Ref: 4535LE/L0077

3rd February 2025

RESPONSE TO CONSULTEE COMMENTS IN RELATION TO FULL PLANNING APPLICATION FOR ERECTION OF A RESIDENTIAL DEVELOPMENT OF 115 DWELLINGS WITH ASSOCIATED ACCESS, CAR PARKING, LANDSCAPING AND DRAINAGE FOLLOWING DEMOLITION OF THE EXISTING B&M RETAIL UNIT AND ASSOCIATED GARDEN CENTRE AT B&M HOME STORE, KINGSWAY, MANCHESTER M19 1BB (REF. 141306/FO/2024)

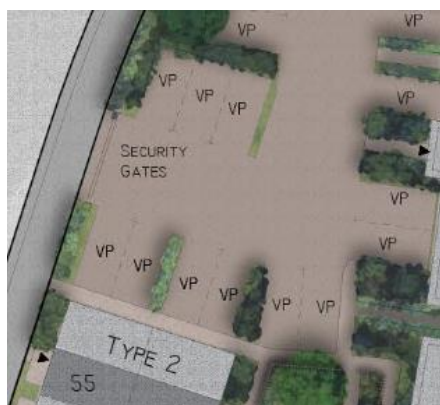
Comment - There are no gates proposed to the apartment car parking areas to the North of the site, and while not essential these would increase the security of the development and prevent commuters using the train from parking without authorisation.

Response from STEN Architecture - Security Gates are shown on our proposals (see below).

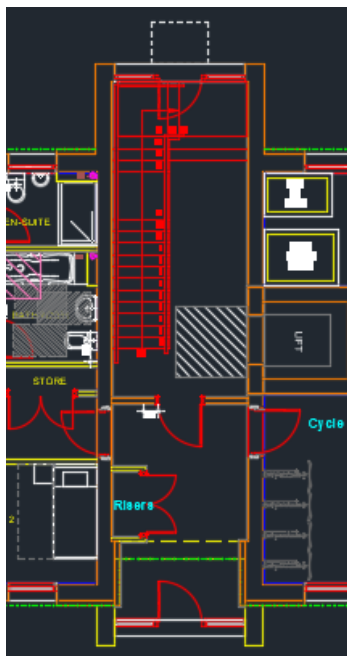
Comment - The car parking areas should be illuminated to a high standard. The path along the east of the site and in front of plots 110 - 115 should be illuminated to a high standard. Lighting to access road should be evaluated and increased to meet adoptable standards where necessary. This will provide some degree of safety and encourage improved natural surveillance from the houses, pedestrians and vehicles.

Response from STEN Architecture - Noted. We will pass these comments onto the lighting design engineer.

We consider that these details can be secured by condition and welcome your confirmation.
